SAN FRANCISCO PLANNING DEPARTMENT

Discretionary Review Abbreviated Analysis HEARING DATE: DECEMBER 20, 2018

Date: December 7, 2018
Case No.: **2017-010924DRP**
Project Addresses: **10-12 Aladdin Terrace**
Permit Applications: 2017.1103.3069
Zoning: RM-1[Residential Mixed, Low Density]
40-X Height and Bulk District
Area Plan: N/A
Block/Lot: 0100/034A, 035A
Project Sponsor: Eric Dumican
Dumican Mosey Architects
128 10th St. 3rd floor
San Francisco, CA 94103
Staff Contact: David Winslow – (415) 575-9159
David.Winslow@sfgov.org
Recommendation: **Do Not Take DR and Approve**

Proposed Building, 10 – 12 Aladdin

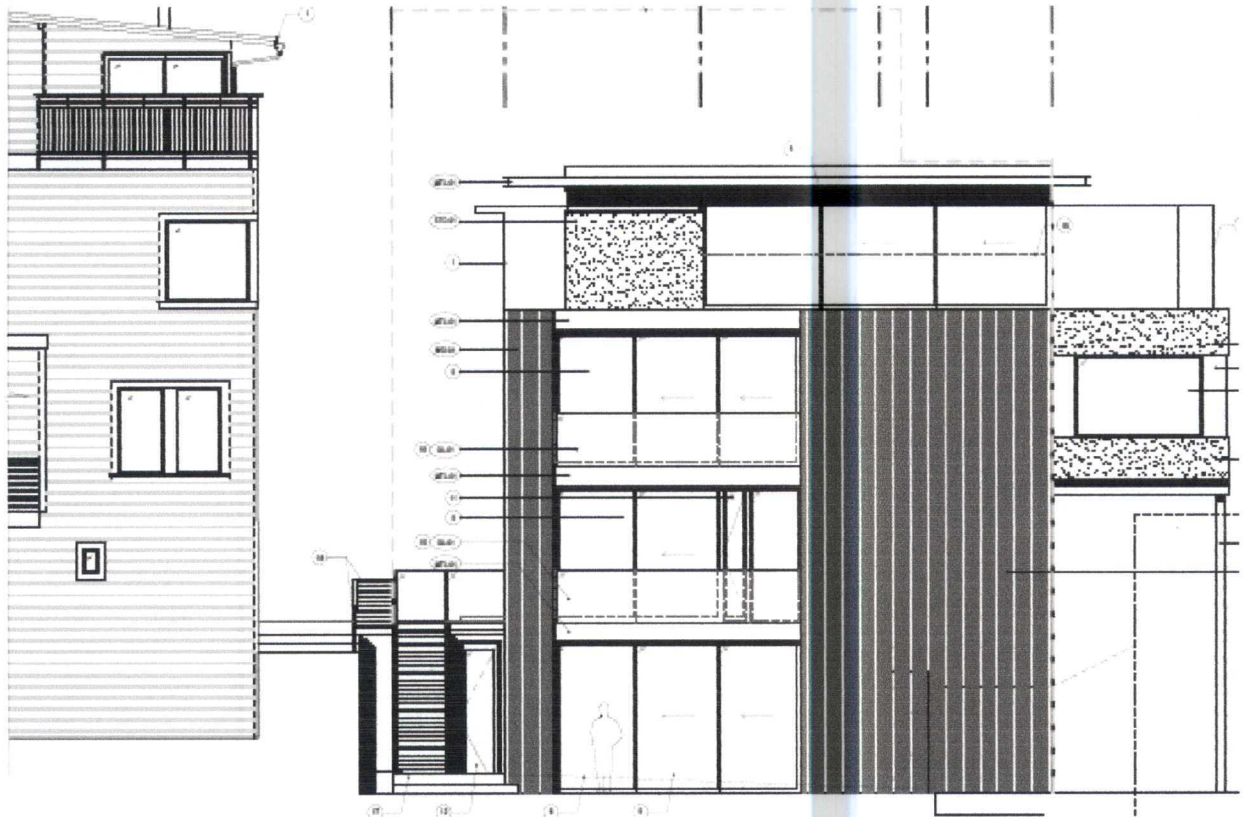
The drawing below shows an image of the proposed windows at 10 – 12 Aladdin on the right, and existing windows on the building at 1 – 3 Aladdin to the left, on the south side of Aladdin directly across from the subject property. This image illustrates the extreme discrepancy between what has been proposed and typical conditions in the surrounding area.

In addition, the proposed finish materials do not relate well to the other buildings on the block. These windows would occupy a far greater percentage of the surface area than windows at the buildings in the neighborhood. The majority of buildings feature either painted stucco or painted horizontal wood or some sort of composite siding, and many of the ground floors are clad with brick or masonry. The proposed materials: stained vertical wood slats, huge panes of glass with minimal aluminum frames, aluminum panels, and glass guardrails will result in an incongruous and disruptive presence in a very prominent location overlooking the middle of the block at the end the cul-de-sac alley.

3 PROPOSED EXTERIOR ELEVATION - EAST (SIDE)

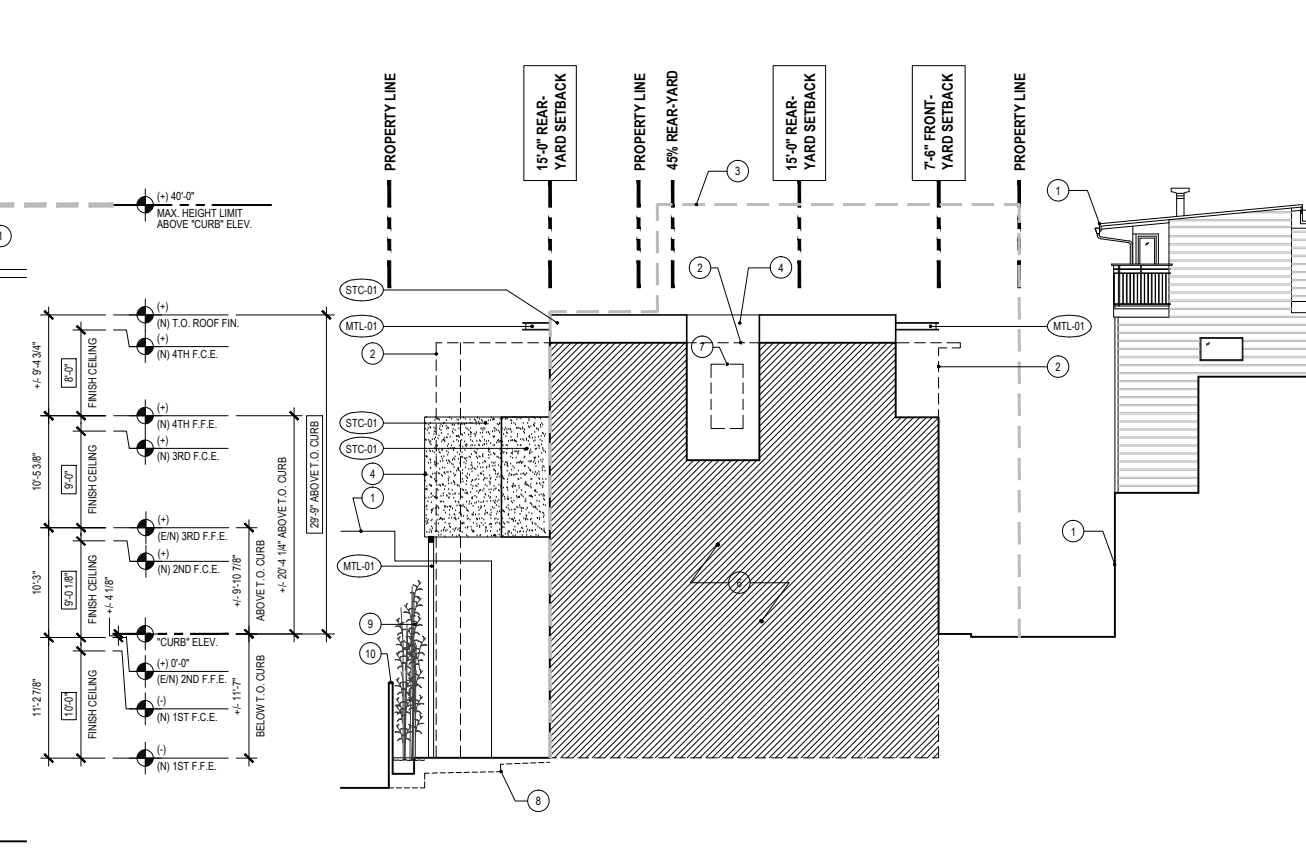
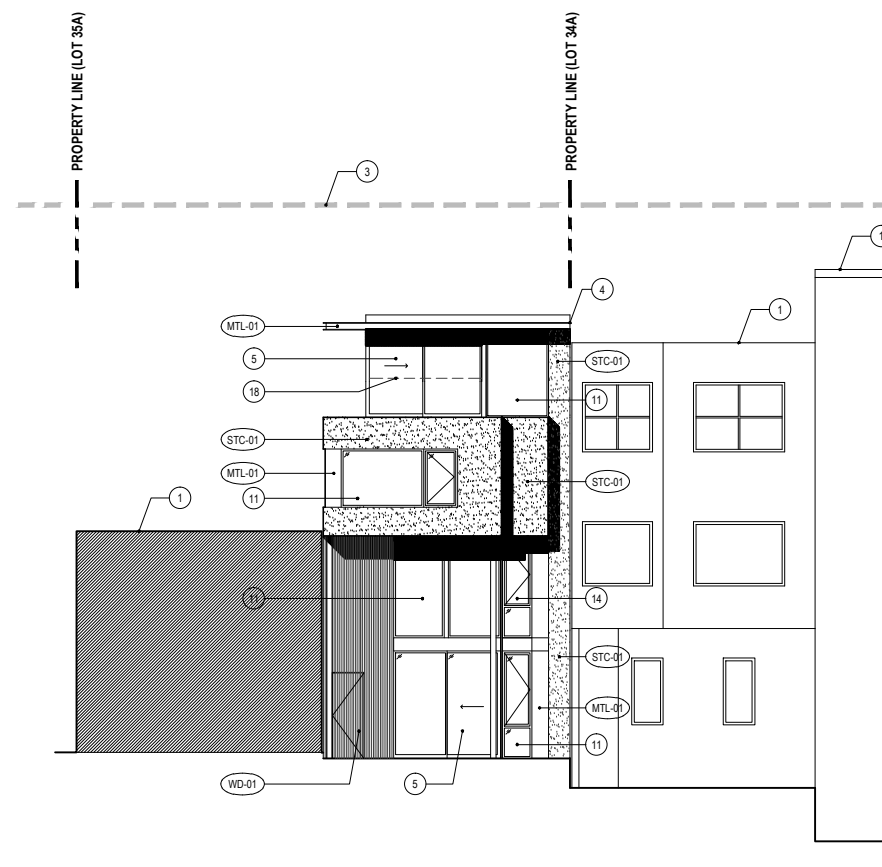
1. Size and extent of windows will contribute to the loss of privacy, unnecessary glare, and night time illumination; they are incompatible with the scale and pattern of the context at the mid-block open space.
2. Proposed exterior materials are incompatible with those found in the context.

Alternative: Request relating the size and proportions of windows to better align with those found on the neighboring buildings; and require a neutral tone non-reflective finish for aluminum panels.

The DR Requestor asserts that the Project's eastern façade – the one facing the DR Requestor's property – features window openings and finish materials that are not compatible with the neighborhood. The DR Requestor singles out one façade – facing their property – and does

1. The overall window to solid wall ratio seems on the whole balanced. Issues of privacy, glare, and nighttime illumination do not seem exceptional or extraordinary with a distance separating the two properties in excess of 90'.
2. The primary façade materials are stained wood and stucco.
